APPLICATION FOR AMENDMENT TO
OPERATING LICENSE

Indian Point Unit No. 3

Docket No. 50-286

April 18, 1977

Figure 3.10-2a Fuel Rod Bow $F_{\Delta H}^N$ Penalty Versus Region Average Burnup

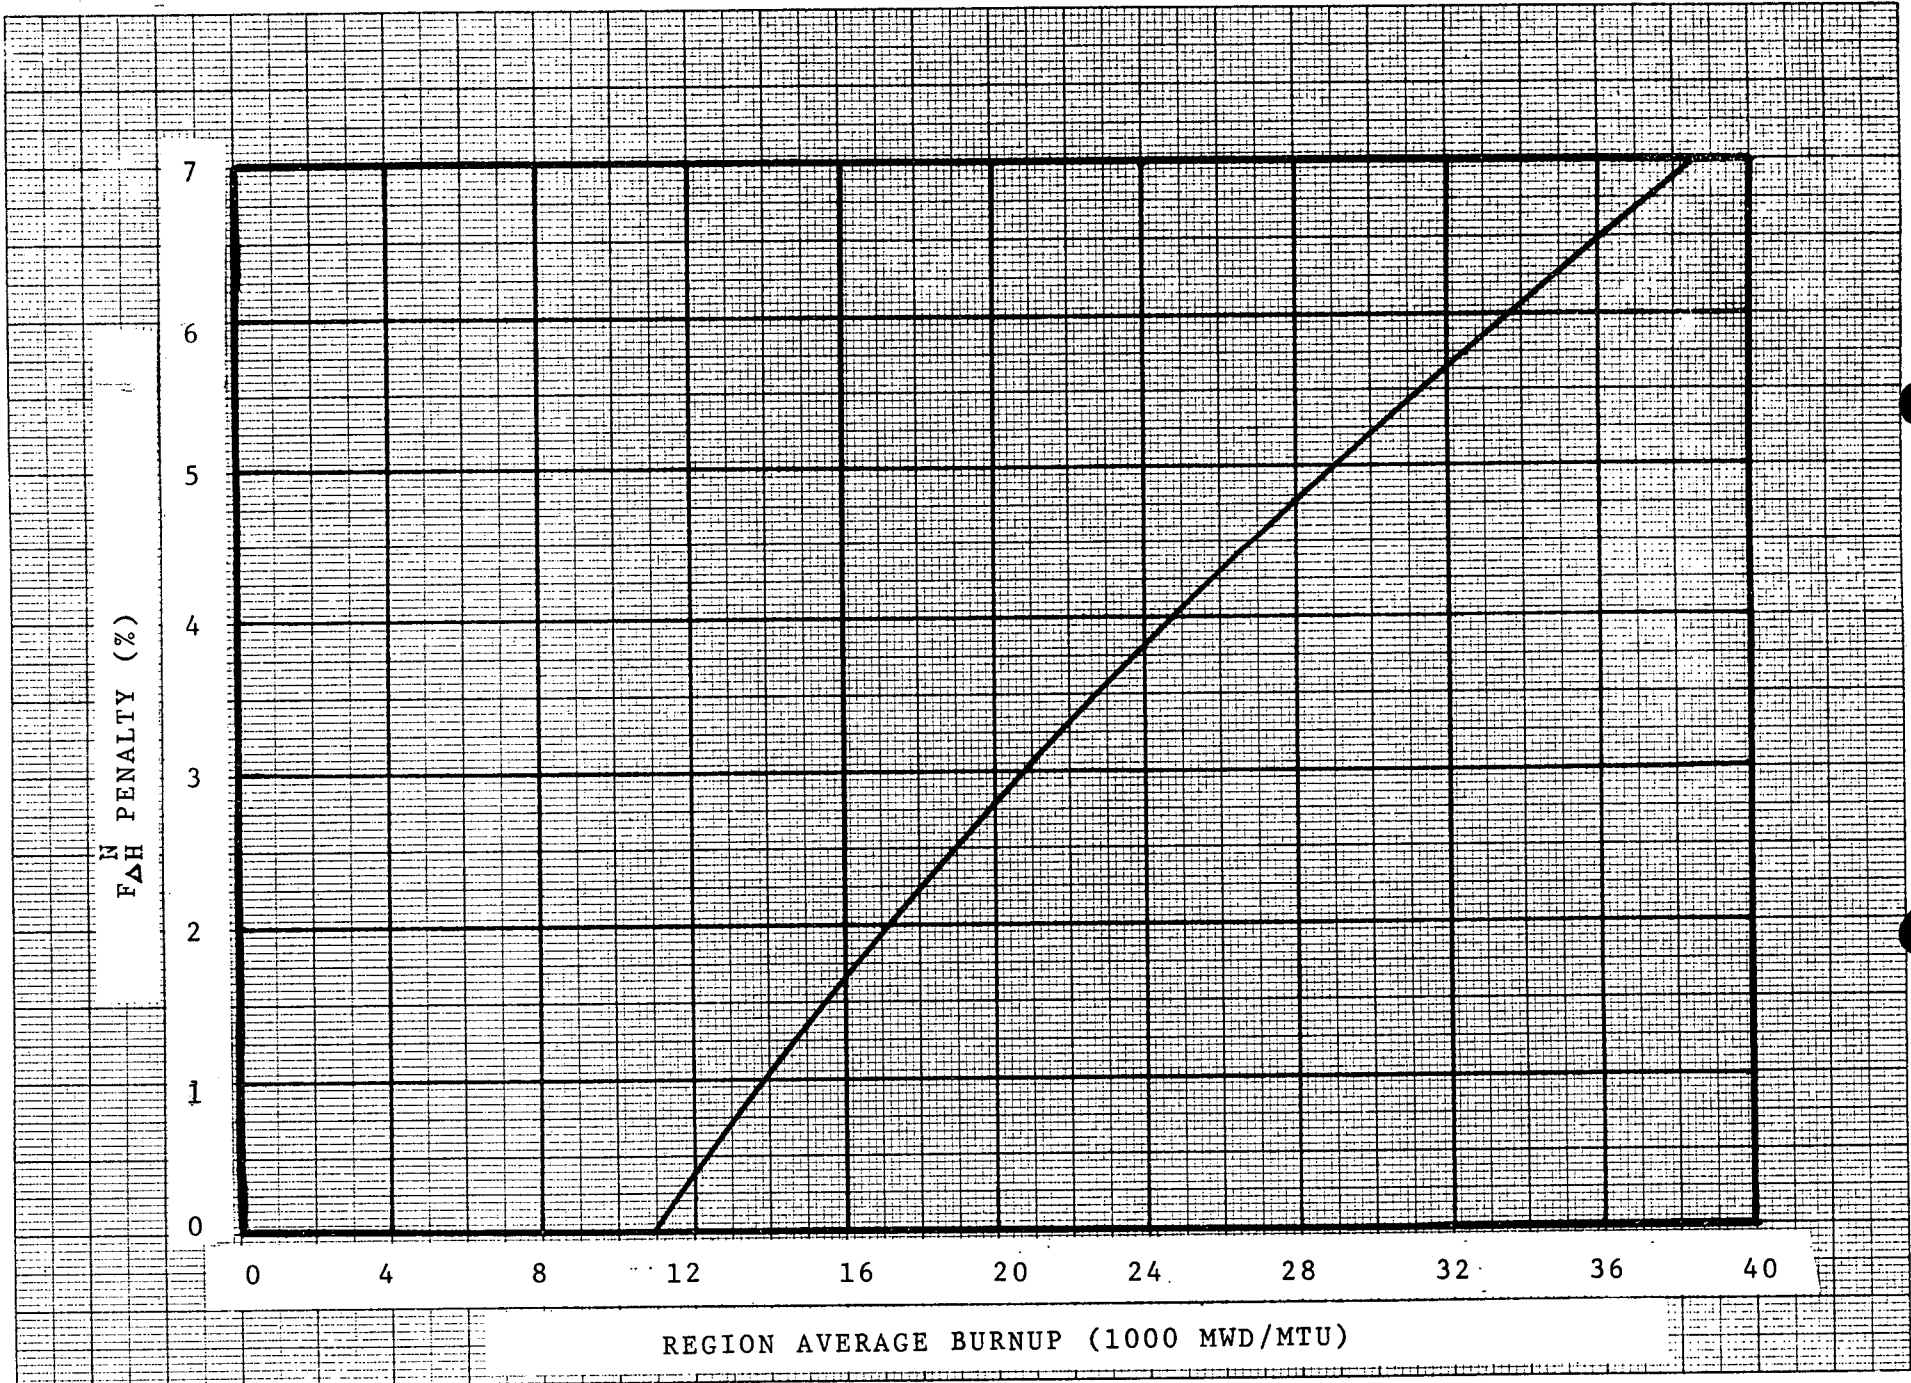
where P is the fraction of full power at which the core is operating. K(Z) is the fraction given in Figure 3.10-2 and Z is the core height location of F_Q . The $F_{\Delta H}^N$ Penalty, as a function of region average burnup, is given in Figure 3.10-2a, and as further modified by specification 3.10.2.2.2.

The $F_{\Delta H}^H$ limit (Specification 3.10.2.1) includes the effect of fuel rod bowing. This bowing has been observed in Westinghouse LOPAR fuel, and exceeds the design value assumed in the pitch reduction. Conservative models [3] have been developed to account for the effect of fuel rod bow on DNB. These models in conjunction with the generic DNB margins appropriate for Indian Point Unit No. 3 result in the $F_{\Delta H}^N$ penalty versus burnup given in Figure 3.10-2a.

In no event shall the margins, due to the increased primary coolant flow and reduced T' , exceed the $F_{\Delta H}^N$ penalty as given in Figure 3.10-2a.
